1984 - 1985 Corvette: Service Bulletin: Noise in Direct Drive 4-Speed Manual Transmission

Bulletin No: 85-111

Figure 1

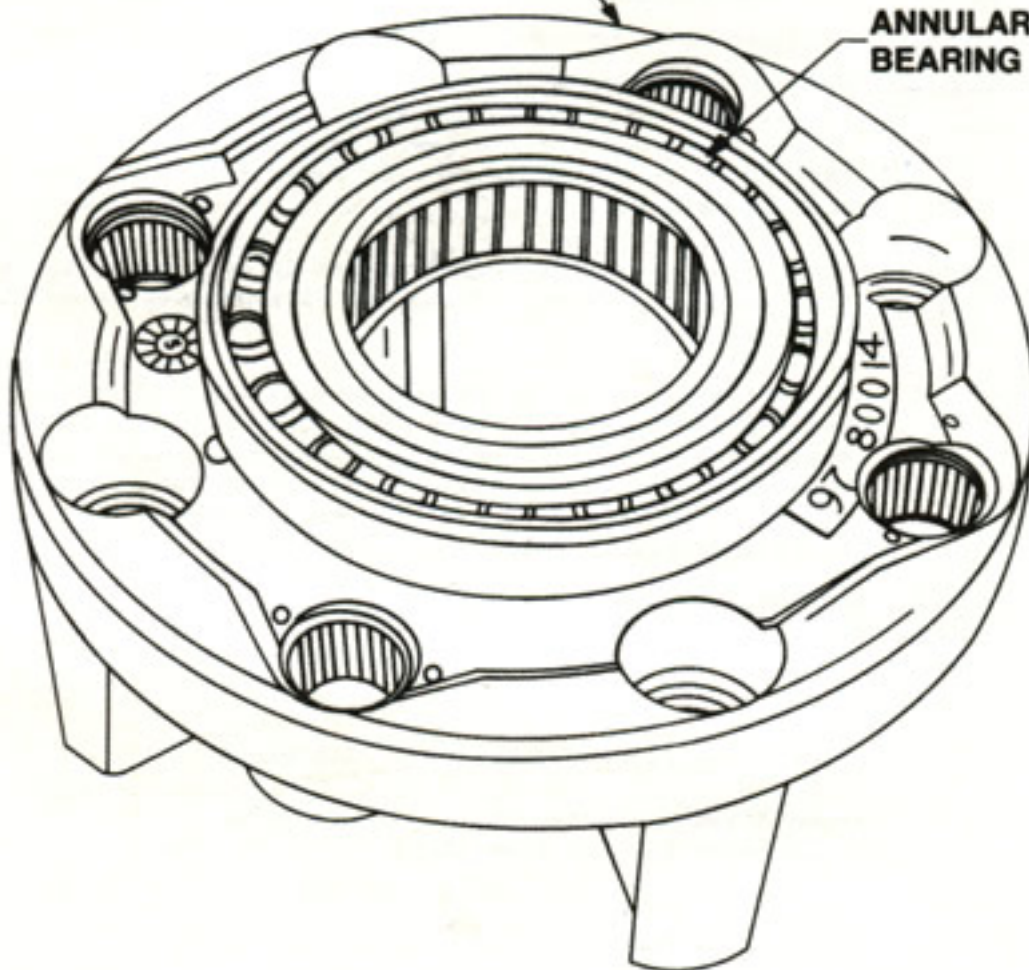
This condition may be caused by a worn annular bearing on the planetary gear carrier (see illustration). Continued operation of a noisy transmission in the direct drive model will cause damage to the planetary carrier, adapter plate, input sun gear, and input sun gear oil seal. If the input sun gear oil seal is damaged, it is possible for overdrive unit oil (Dexron II) to leak into the manual portion of the transmission.

On transmissions beginning with serial number D5C 14413 CF, a new planetary gear carrier has been released. This carrier (P/N 14094571) incorporates an annular bearing with increased thrust capacity.

1. Inspect the adapter plate surface, input sun gear, and input sun gear oil seal for damage. If there is indication of damage, the adapter plate, input sun gear, and input sun gear oil seal should be replaced. If there is no sign of damage, these parts may be reused.
2. If debris is present in the overdrive unit, completely disassemble and clean the unit, including the valve body. Thoroughly flush the cooler lines to remove any debris following the procedure outlined in the Vehicle Service Manual. Replace the oil filter.
3. If there is evidence of oil intrusion from the automatic overdrive unit into the 4-speed manual unit, the manual unit should be drained and flushed also.
4. Replace the planetary gear carrier with the new, P/N 14094571, carrier.

NOTICE: When an overdrive unit from a transmission built prior to serial number D5C 14413 CF is disassembled for any reason, it is recommended that a new, P/N 14094571, planetary gear carrier be installed to prevent potential future annular bearing failures.
